PORTION OF SE QUARTER OF SEC 27, TWN 20 N, RGE. 4 E, W.M.
CITY OF PUYALLUP, PIERCE COUNTY, WASHINGTON
ROUGH GRADING & TESC PLAN

Job Number: 22085
Sheet: E3 of 7

Title: ROUGH GRADING & TESC PLAN
FORTRESS - PUYALLUP

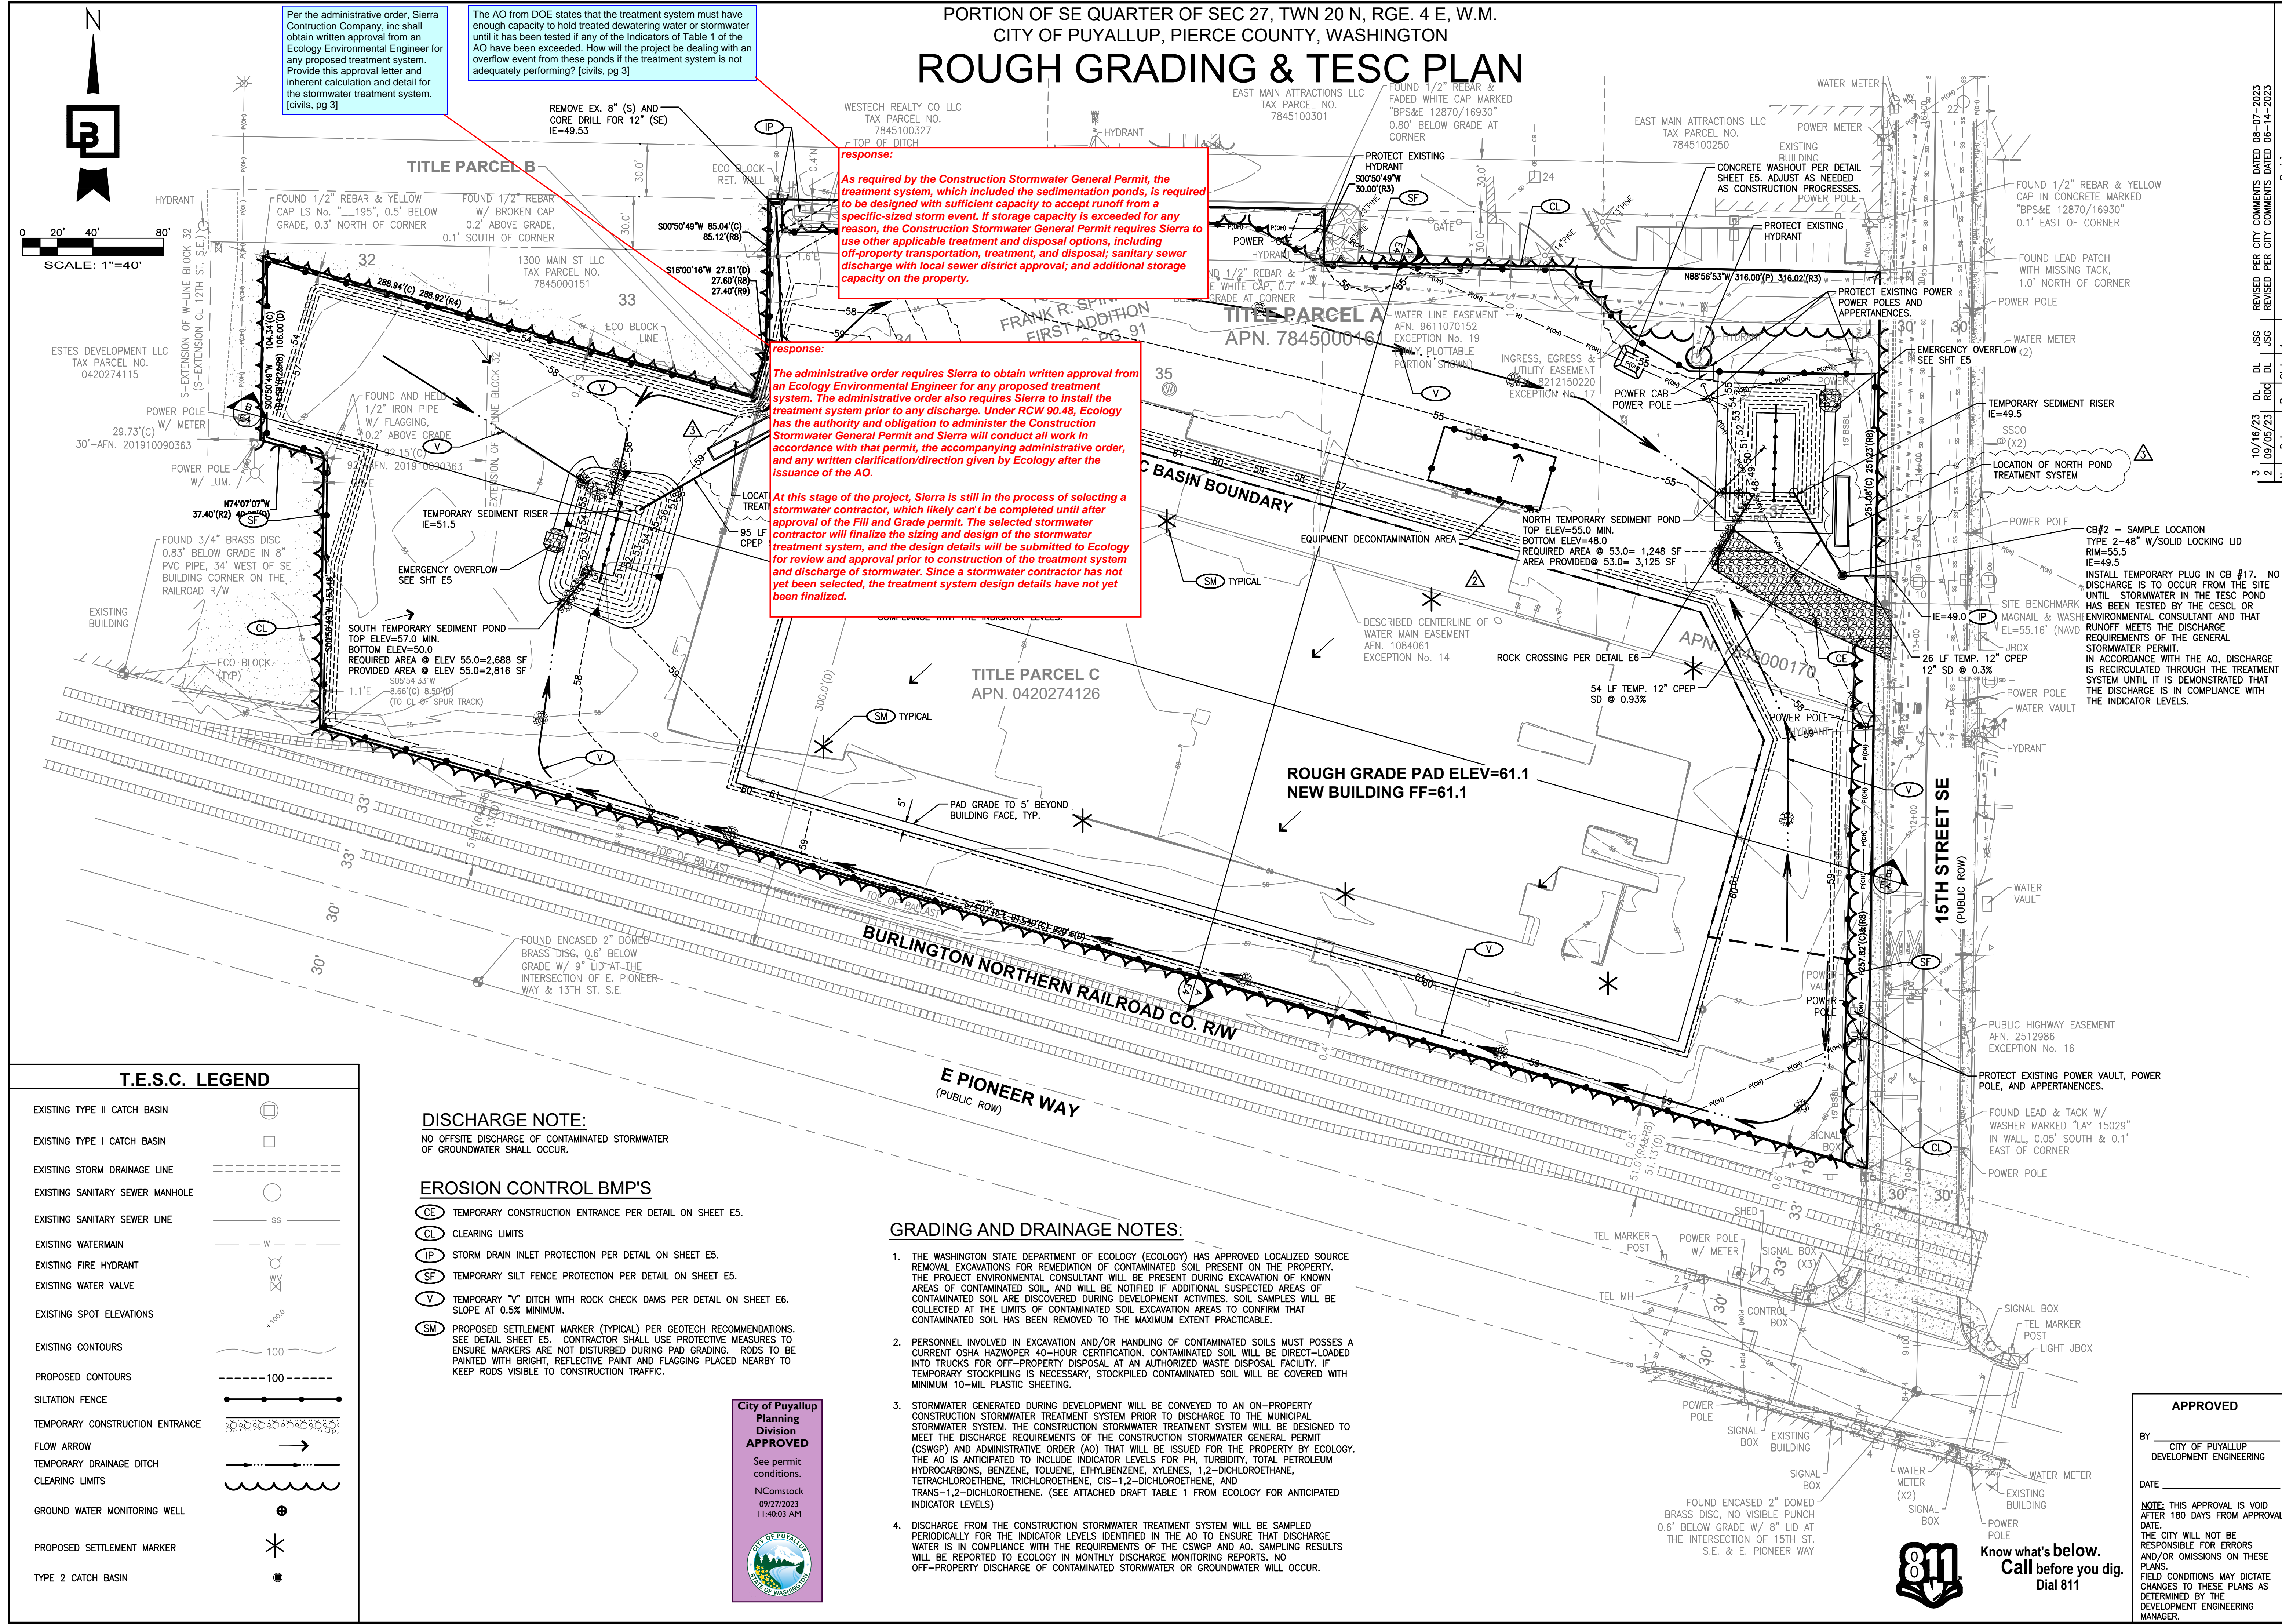
Per the administrative order, Sierra Construction Company, inc shall obtain written approval from an Ecology Environmental Engineer for any proposed treatment system. Provide this approval letter and inherent calculation and detail for the stormwater treatment system. [civils, pg 3]

The AO from DOE states that the treatment system must have enough capacity to hold treated dewatering water or stormwater until it has been tested if any of the Indicators of Table 1 of the AO have been exceeded. How will the project be dealing with an overflow event from these ponds if the treatment system is not adequately performing? [civils, pg 3]

response:
As required by the Construction Stormwater General Permit, the treatment system, which included the sedimentation ponds, is required to be designed with sufficient capacity to accept runoff from a specific-sized storm event. If storage capacity is exceeded for any reason, the Construction Stormwater General Permit requires Sierra to use other applicable treatment and disposal options, including off-property transportation, treatment, and disposal; sanitary sewer discharge with local sewer district approval; and additional storage capacity on the property.

response:
The administrative order requires Sierra to obtain written approval from an Ecology Environmental Engineer for any proposed treatment system. The administrative order also requires Sierra to install the treatment system prior to any discharge. Under RCW 90.48, Ecology has the authority and obligation to administer the Construction Stormwater General Permit and Sierra will conduct all work in accordance with that permit, the accompanying administrative order, and any written clarification/direction given by Ecology after the issuance of the AO.

At this stage of the project, Sierra is still in the process of selecting a stormwater contractor, which likely can't be completed until after approval of the Fill and Grade permit. The selected stormwater contractor will finalize the sizing and design of the stormwater treatment system, and the design details will be submitted to Ecology for review and approval prior to construction of the treatment system and discharge of stormwater. Since a stormwater contractor has not yet been selected, the treatment system design details have not yet been finalized.
